**Dear Dr. Andrei Shkel,**

The manuscript presents the development of a data collection device for monitoring hens. This document provides some review for the comments to the author and some explanation for these decisions.

Reviewer: 1

Figure 1: Reference figure for quantitative analysis

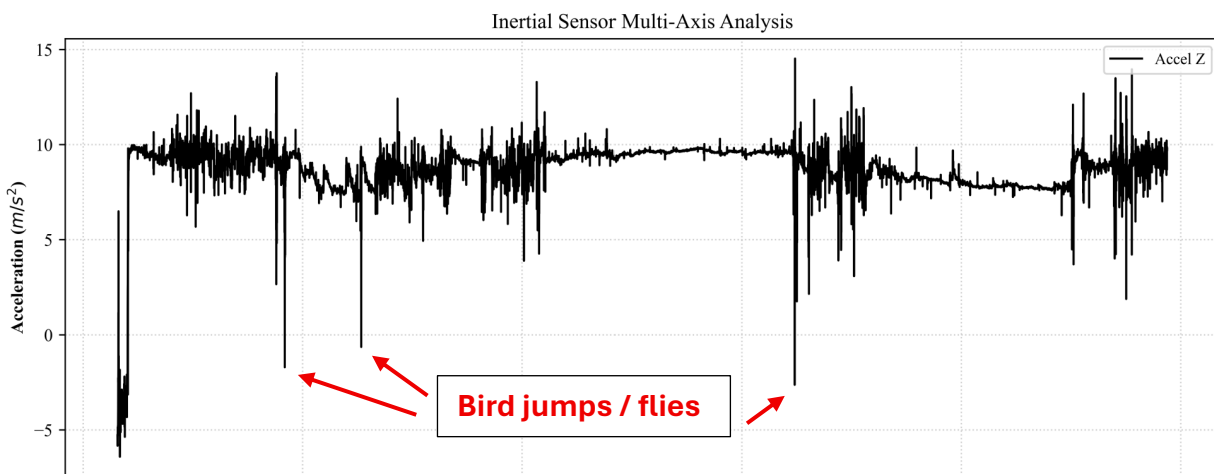
1. The signal processing and data analytics aspects are relatively limited, with the results primarily presented through qualitative graphical observations.

Correct. We only have a single figure (4a and 4b in the original paper), with data analysis. At the time stamps at 12:15, 13:30, and 14:15 seconds, you see the bird do slight movement upwards and then abruptly drop, indicating the effect seen in the figure below. More qualitative observations have been added in the paper.
